| PROJECT NAME: | MANCHESTER-RUTLAND TOWN |
| PROJECT NUMBER: | NH SURF(50) |
| TRAFFIC SIGNAL SYSTEM SHEET 2 | |
| SHEET | 86 OF 105 |

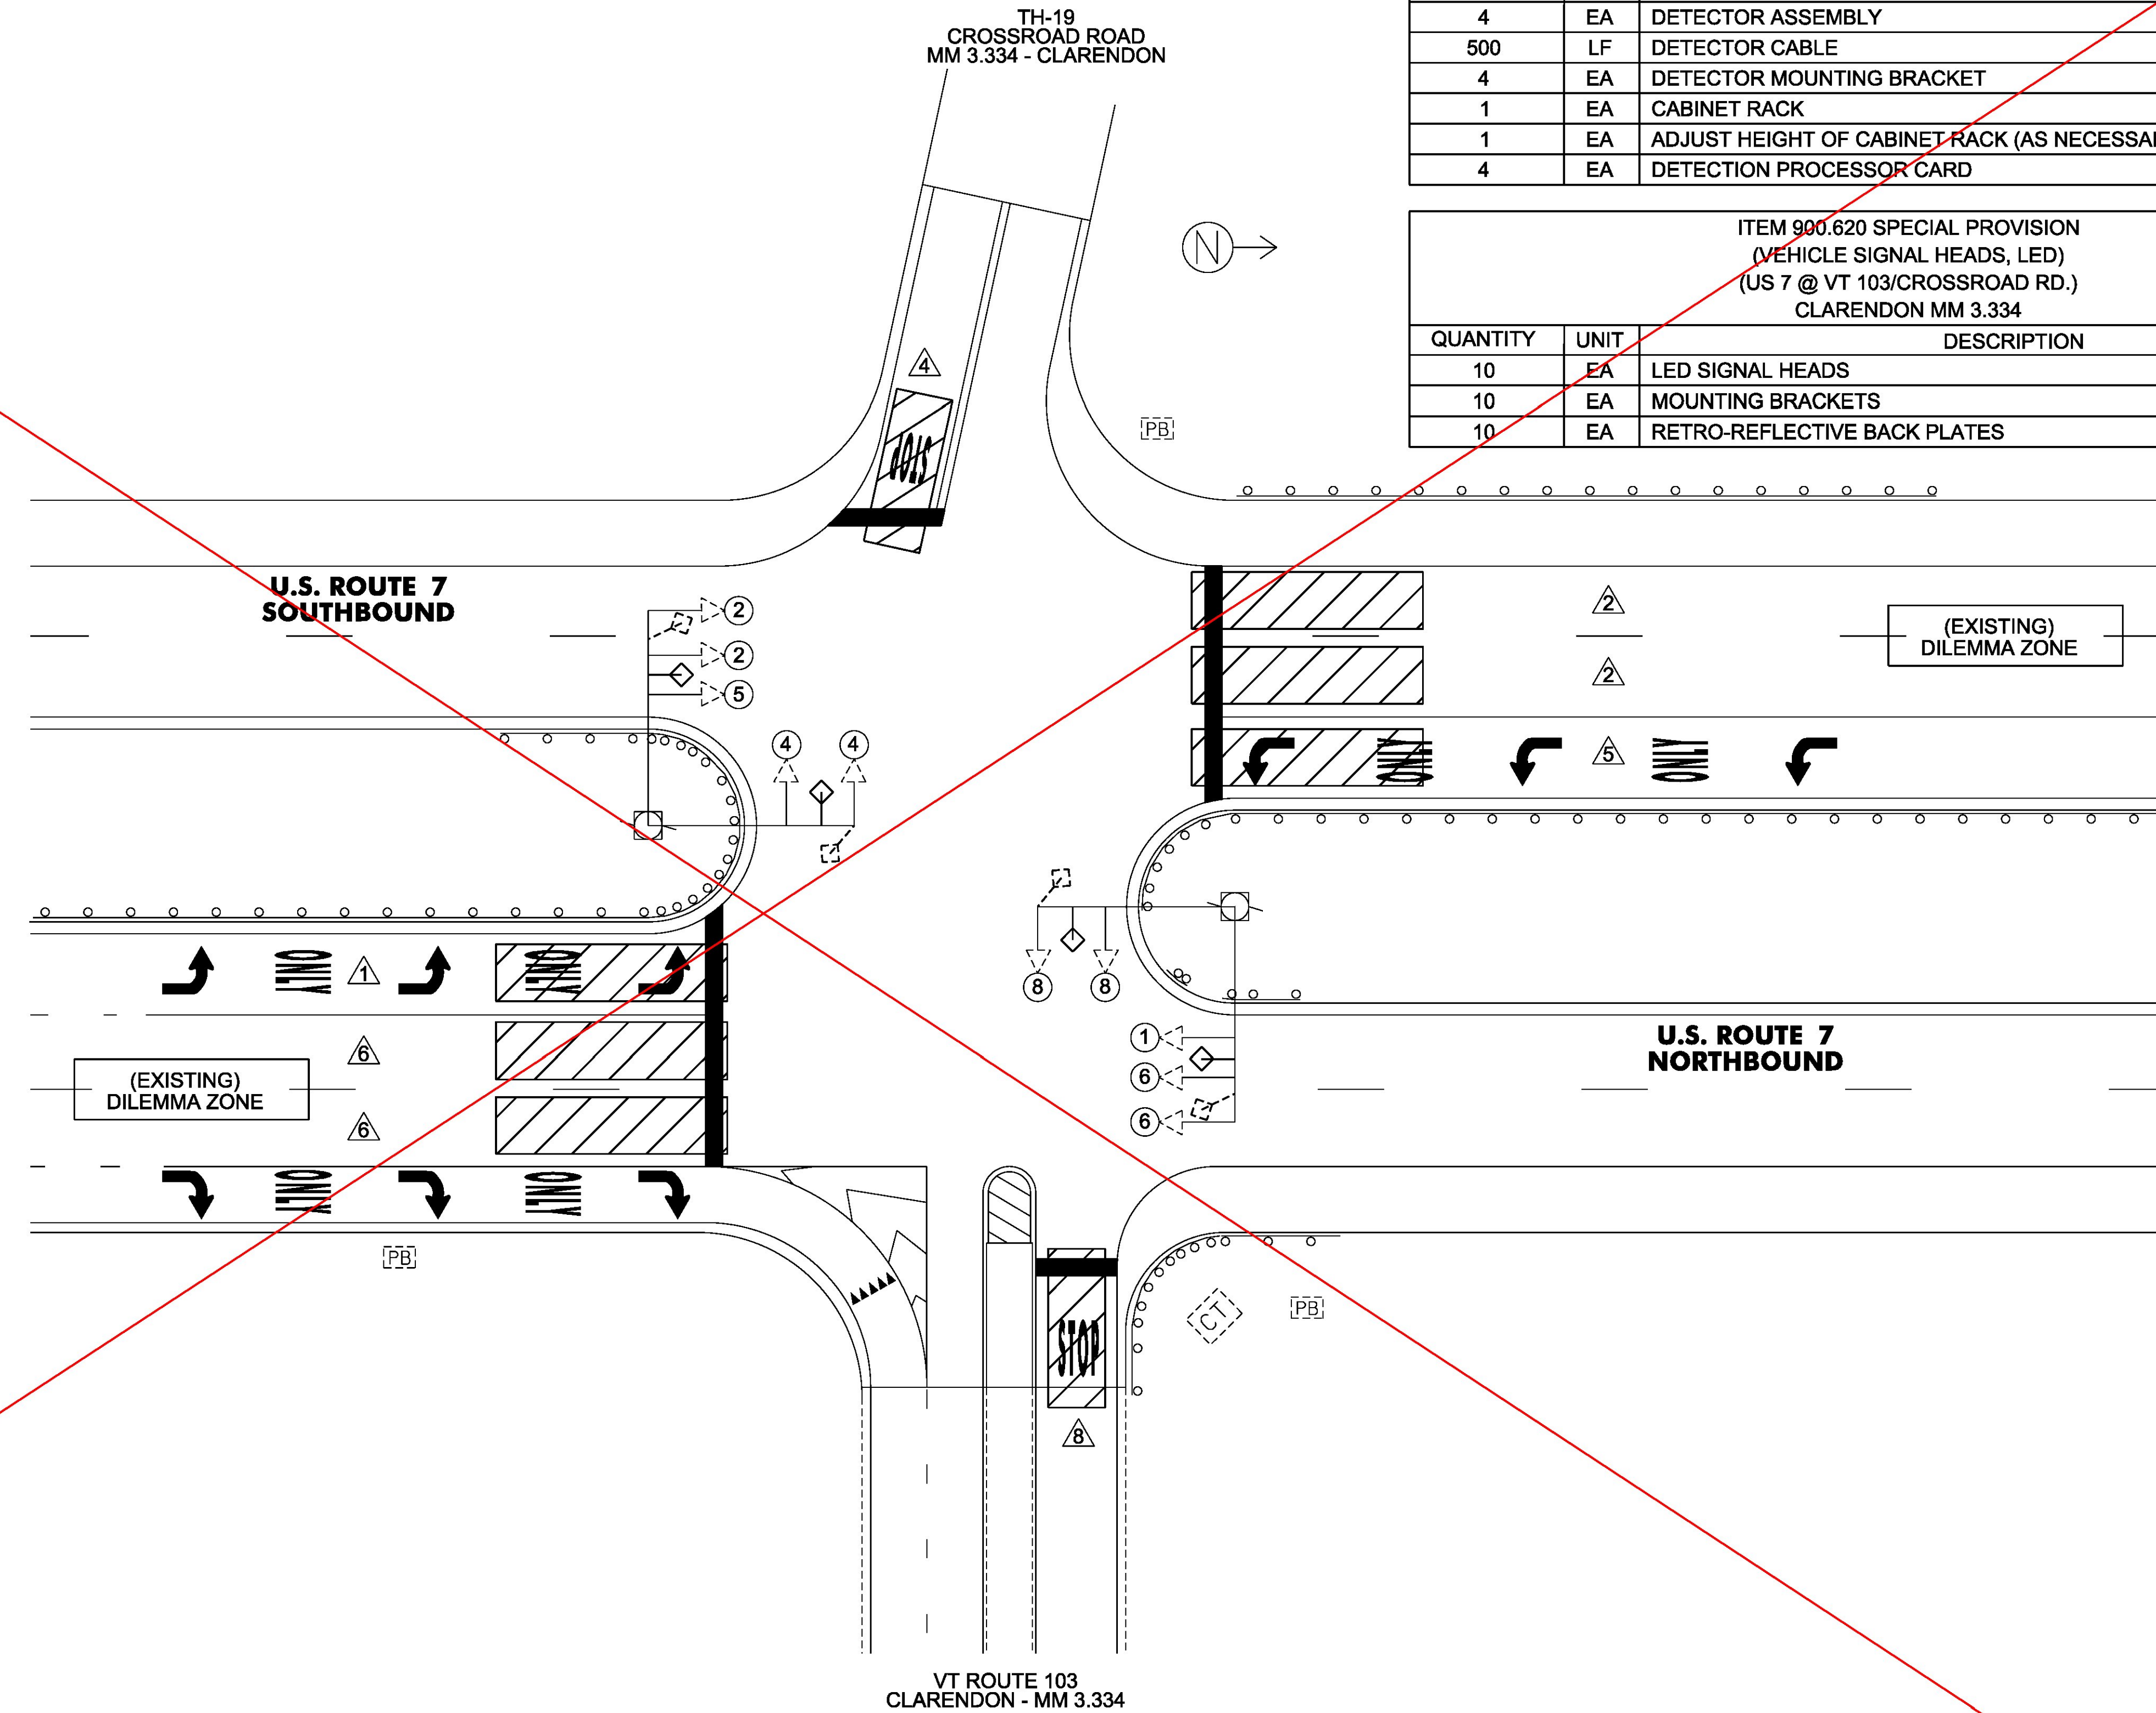
see revised sheet
